## Development Permit Panel

Wednesday, August 24, 2016  
3:30 p.m.

1. **Development Permit 10-521415**  
(REDMS No. 4707564)

PROPERTY LOCATION: 6551 Williams Road (formerly 6511/6531 and 6551/6553 Williams Road)

**SOUTH (WILLIAMS ROAD)**

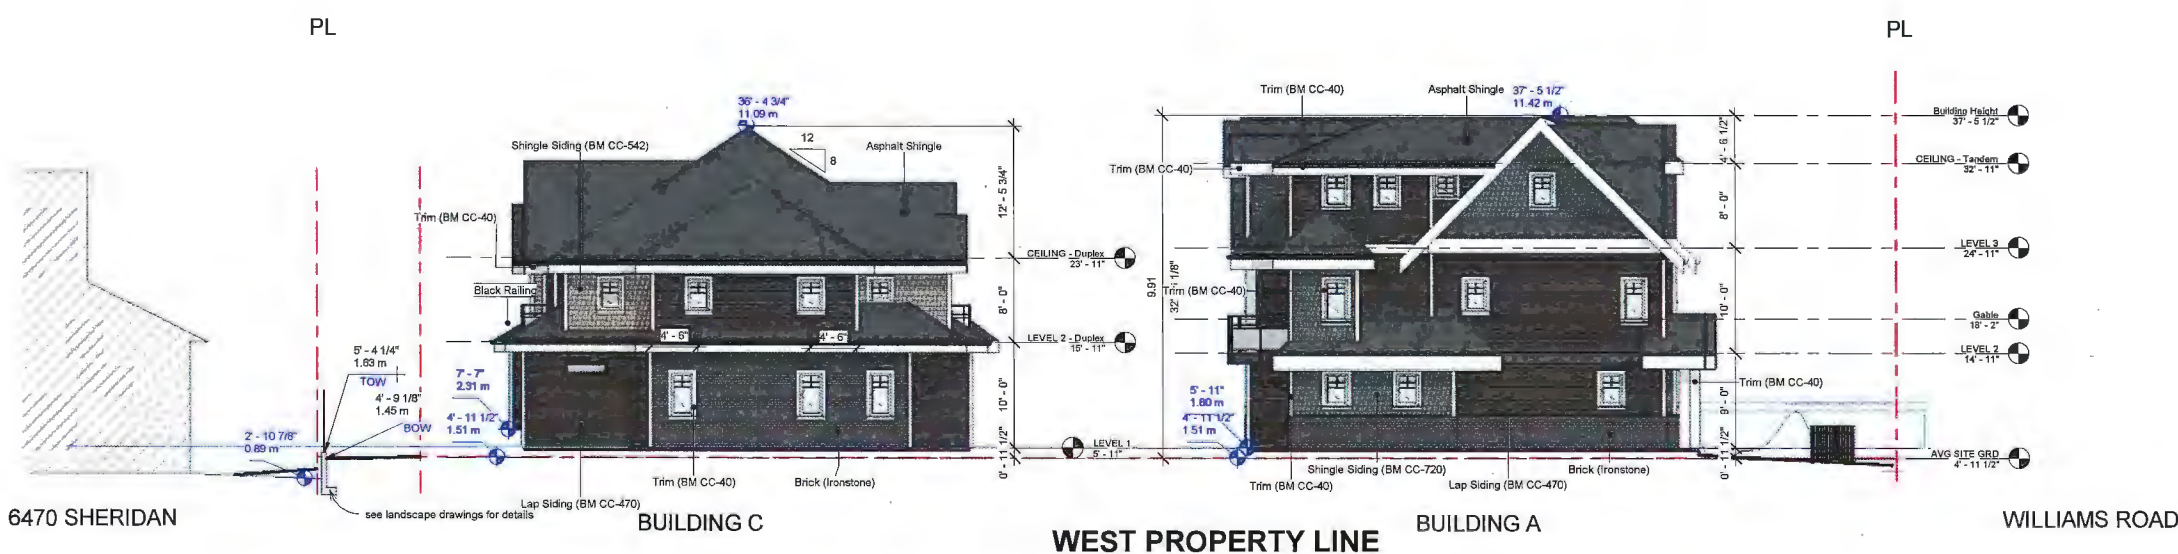
- consider lowering the height of entry gables along Williams Road to provide relief to the windows above;  
*The height of entry gables has been decrease 10.5" from bottom of the above windows, changing the slope of the gables.*
